## ADDENDUM

SUBJECT: **ADDENDUM TO ITEM F10d COASTAL DEVELOPMENT PERMIT  
APPLICATION NO. 5-21-0079 (Viloria) FOR THE COMMISSION MEETING  
OF FRIDAY, AUGUST 13, 2021**

# Viloria Residence Deck Addition 225 W. Marquita

To review the proposed 5' cantilevered deck encroachment  
Into the required 5' Coastal Canyon Setback

225 W. Marquita

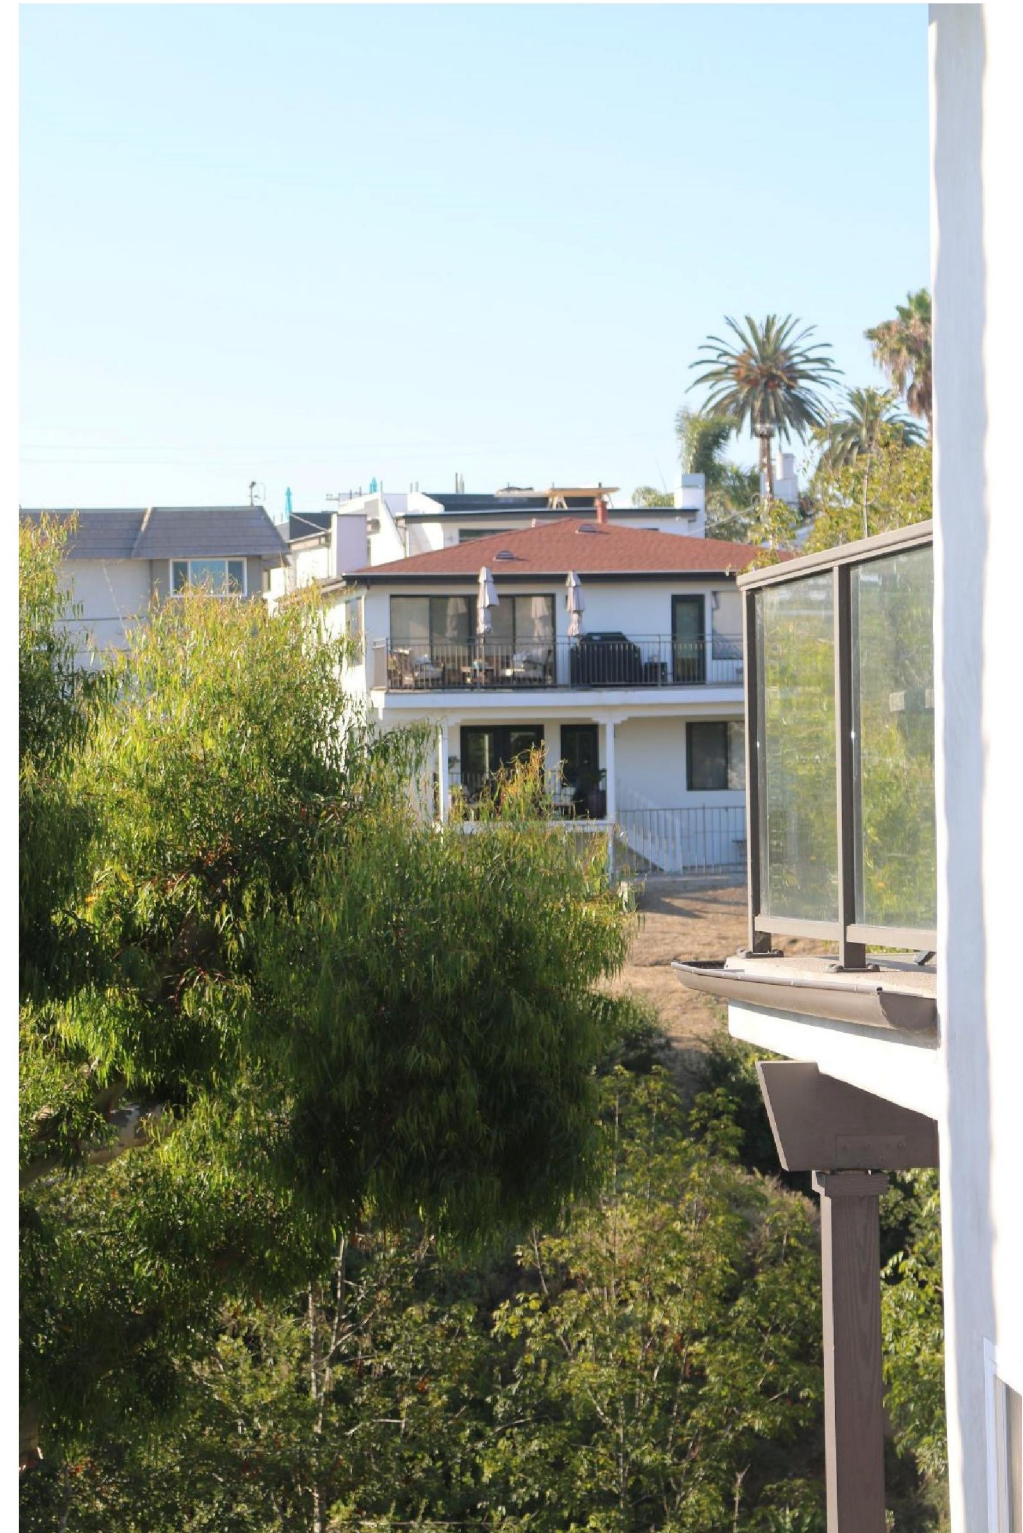
Building on and Decks over Canyon Edge

Proposed Deck Will Not be on or over Canyon Edge.
